Office Action Summary

10/730,852

OYU ET AL.

DETAILED OFFICE ACTION

Fig. 2 PRIOR ART

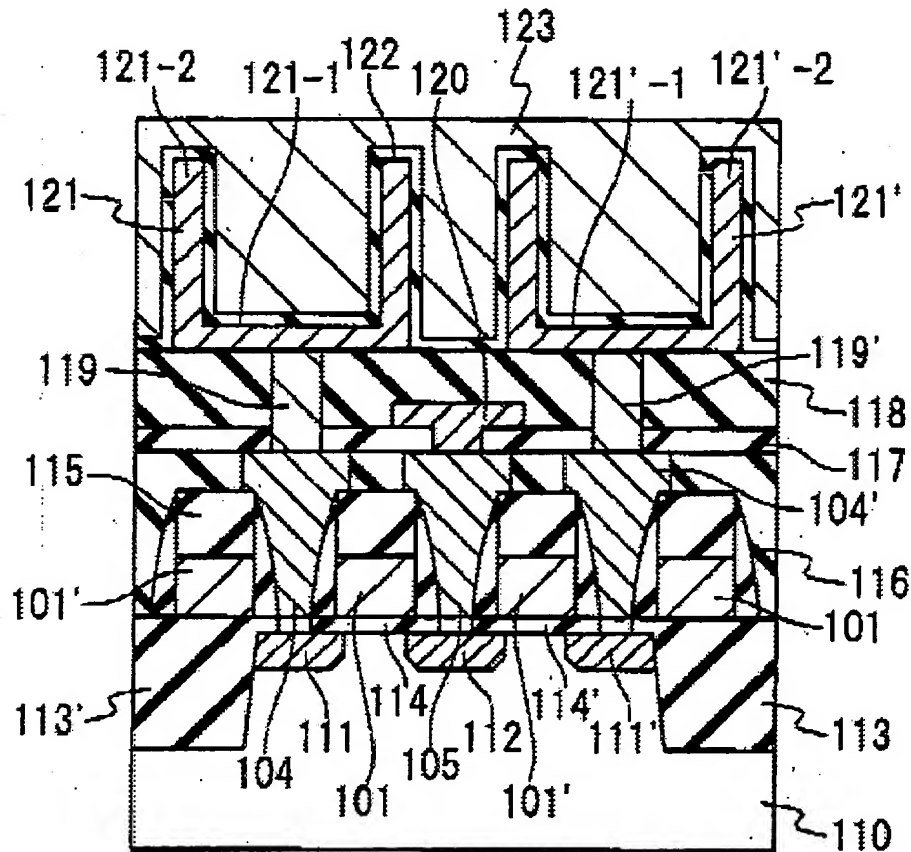
The AAPA (as shown in fig 1, fig 2, the background section of the application 0 discloses all the invention except is silent about the gate length that is longer than the processing dimension. Bronner, however (column 2 lines 52-53) discloses that a gate length longer than the processing dimension can be use to cure a leakage problem in DRAM.

Fig. 5

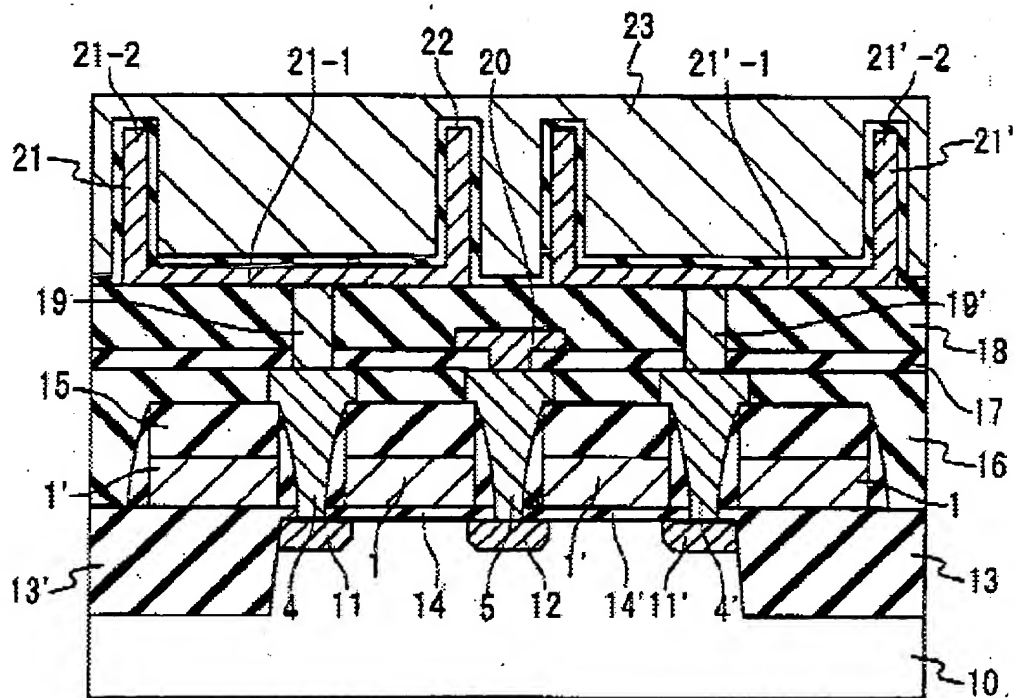
6. Claims 3-4 are rejected under 35 U.S.C. 103(a) as being unpatentable over the Applicant Admitted Prior Art (the AAPA) in view of Bronner (U.S. patent 6,767,789).

It would have been obvious to one of ordinary skill in the art the time the invention was made to complement the teachings by the AAPA with the teachings by Bronner in order to come up with the invention of claim 3-4.
